1963 Corvette: Chevrolet Advance Information: Engine Crankcase Backfire

Subject: Engine Crankcase Backfire

Bulletin Number: #AI-63-10

Date: February 12, 1963

1963 CORVETTE AIR CLEANER BASE

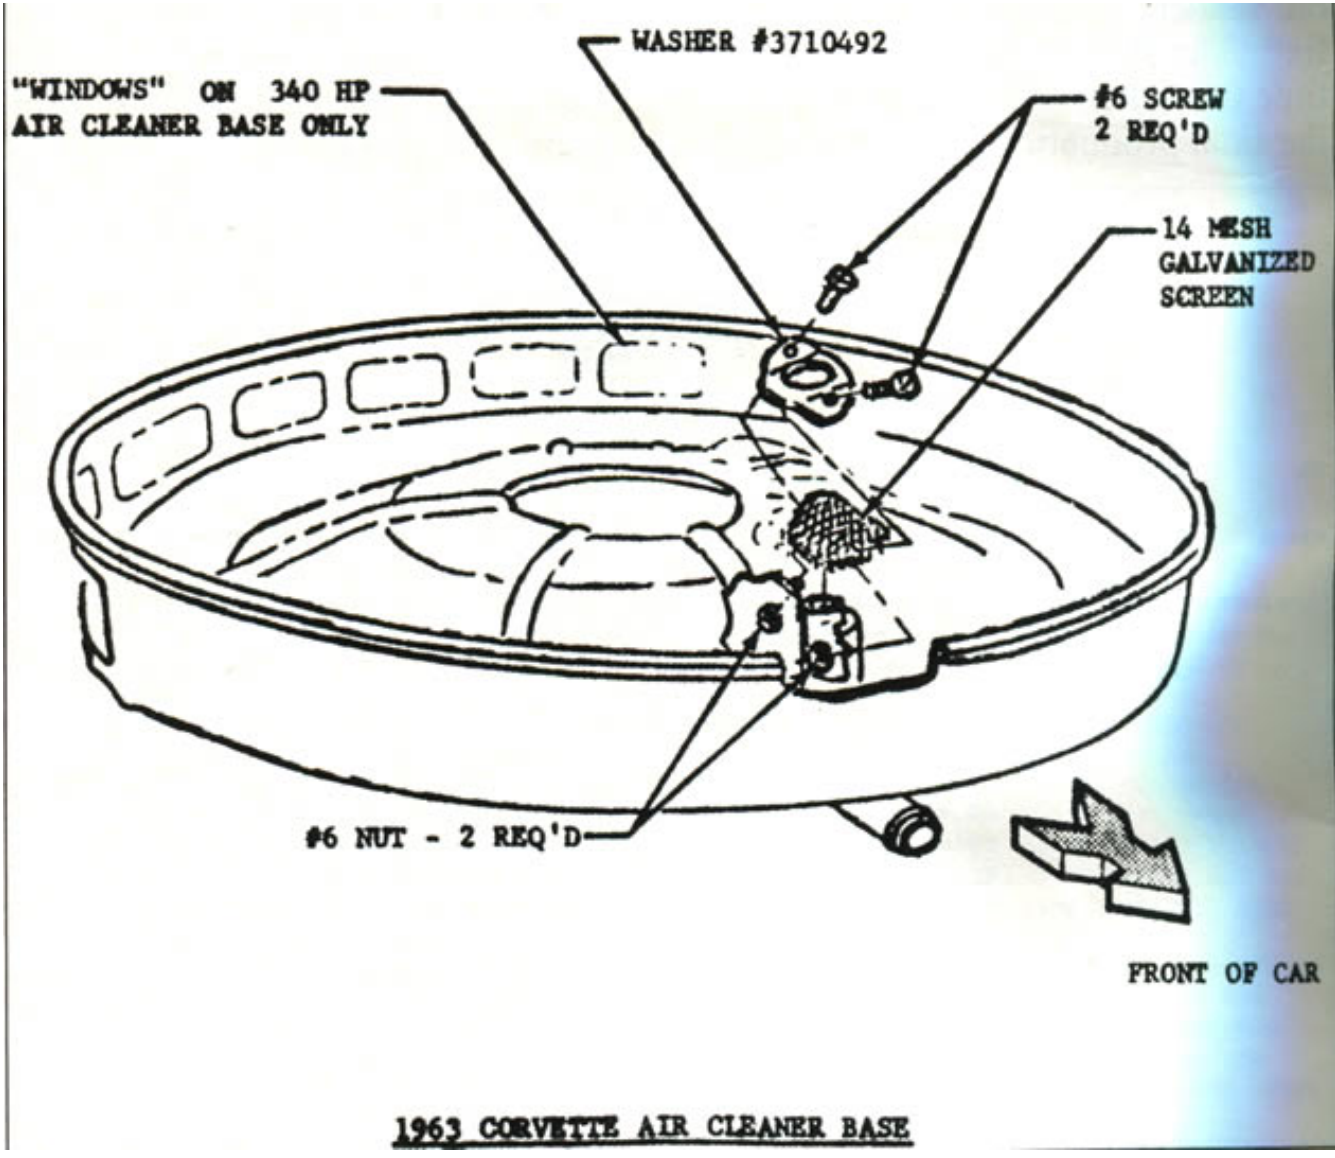
An accidental carburetor backfire during severe cold-weather starts, may result in a flame traveling down the air cleaner to crankcase vent fresh air supply tube, igniting the fumes in the crankcase. In extreme cases, the resulting explosion may damage the oil pan and rocker covers.

A final production correction has not been determined at this time; however, installation of a flame arrestor screen to the inside of the air cleaner (as illustrated on the attached sheet) will prevent re-occurrence of this condition.

Using 14 mesh galvanized screen, cut a circle approximately 1-1/2" in diameter and solder around outer edge of screen to prevent individual wires from being sucked into the engine.

Bend brake anchor pin washer Part No. 3710492, to fit contour of air cleaner. Position washer and drill two (2) 5/32" diameter holes through washer and air cleaner base. Place galvanized screen under washer and secure with two (2) #6 screws and nuts.

NOTE : Ends of screws must be cut short and "peened" over nut to keep engine vibration from loosening screws, allowing them to be swallowed through the carburetor.
